THE S20-1 WOOD STOVE UPDATED TO HAVE BETTER CLEARANCES!

A new reduced clearance heat shield (Product Code: RCHS20) is also now available as an accessory for the S20-1*.

RCHS20

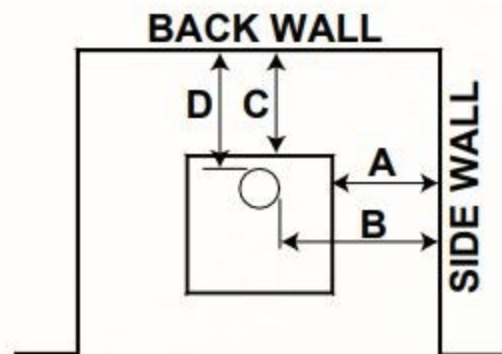
*RCHS20 - reduced clearance heat shield fits the S20-1 ONLY. Does not fit the previous S20 model.

CLEARANCE COMPARISON

| Location | S20 Previous Model | NEW S20-1 | REDUCED CLEARANCE HEAT SHIELD |
|----------------------|--------------------|------------------|----------------------------------|
| Sidewall (A) | 13" (33cm) | 12" (30.5cm) | |
| Sidewall to flue (B) | 22 7/8" (58.1cm) | 21 1/2" (54.6cm) | |
| Backwall (C) | 11 1/2" (29.2cm) | 9 1/2" (24.1cm) | 5 1/2" (14cm) |
| Backwall to flue (D) | 15" (38.1cm) | 12 1/2" (31.8cm) | 8 1/2" (21.6cm) |
